# Access Compliance Report

## Public Rights-of-Way (Curb Ramps)

Intersection ID: 3399	Main Street: BUTTON_POINTE_CT	Cross Street: PRESERVATION_POINTE_DR	Location: NW
ADA ID: E69254AB3518	Ramp Type: Perp	Initial Pass/Fail: Fail	Overall Compliance: No Severity Score: 33.75

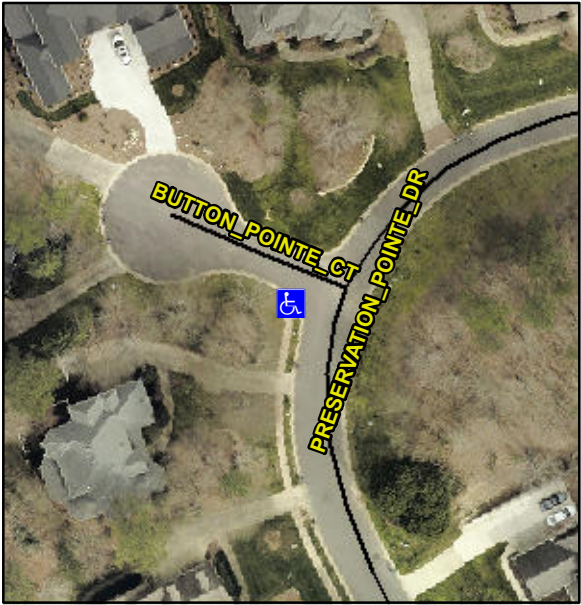
Codes/Mitigation Info/Possible Solution			Field Measurements/Component Compliance		
	Possible Solutions:		<b>Compliance</b>	<b>Description</b>	<b>Data</b>
	<b>Remove &amp; Replace Entire Ramp.</b>		<b>No</b>	Ramp Length (in)	<b>95.0</b>
			<b>No</b>	Ramp Width (in)	<b>47.5</b>
			<b>N/A</b>	Flare Type LT	<b>N/A</b>
			<b>N/A</b>	Flare Slope LT (%)	<b>N/A</b>
			<b>N/A</b>	Flare Traversable LT?	<b>N/A</b>
			<b>N/A</b>	Landing Length (in)	<b>N/A</b>
			<b>N/A</b>	Landing Width (in)	<b>N/A</b>
			<b>N/A</b>	Landing Slope (%)	<b>N/A</b>
			<b>N/A</b>	Landing X Slope (%)	<b>N/A</b>
<p>Surveyor Notes:</p> <p><b>N/A</b></p> <p>PROW/ADA:</p> <p><b>Not Found, R304.5.1, R304.2.2, R304.5.3</b></p>			<b>N/A</b>	Flare Type RT	<b>N/A</b>
			<b>N/A</b>	Flare Slope RT (%)	<b>N/A</b>
			<b>N/A</b>	Flare Traversable RT?	<b>N/A</b>
			<b>N/A</b>	DWS Provided?	<b>N/A</b>
			<b>N/A</b>	DWS Contrast?	<b>N/A</b>
			<b>N/A</b>	DWS Length (in)	<b>N/A</b>

<b>N/A</b>	DWS Full Width?	<b>N/A</b>
			<b>N/A</b>	DWS Offset (in)	<b>N/A</b>
			<b>N/A</b>	Gutter Ponding?	<b>N/A</b>
			<b>N/A</b>	Gutter Lip Ht (in)	<b>N/A</b>
<p>Total Cost:</p> <p><b>\$ 1850.00</b></p>			<b>No</b>	Painted X Walk1?	<b>N/A</b>
			<b>To N</b>	X Walk 2 Direction	<b>N/A</b>
			<b>N/A</b>	X Walk 2 Width (in)	<b>N/A</b>
			<b>3.4</b>	X Walk 2 Slope (%)	<b>N/A</b>
			<b>3.8</b>	X Walk 2 X Slope (%)	<b>N/A</b>
			<b>N/A</b>	Ramp inside XWalk2?	<b>N/A</b>
			<b>3.8</b>	Clear Space?	<b>N/A</b>
			<b>3.4</b>	Clear Space to XWalk (in)	<b>N/A</b>
			<b>N/A</b>	Storm Grate/Utility Hazard?	<b>N/A</b>
			<b>N/A</b>	Storm Grate/Utility Type	<b>N/A</b>
			<b>N/A</b>	Surface Condition? (G/P)	<b>Good</b>
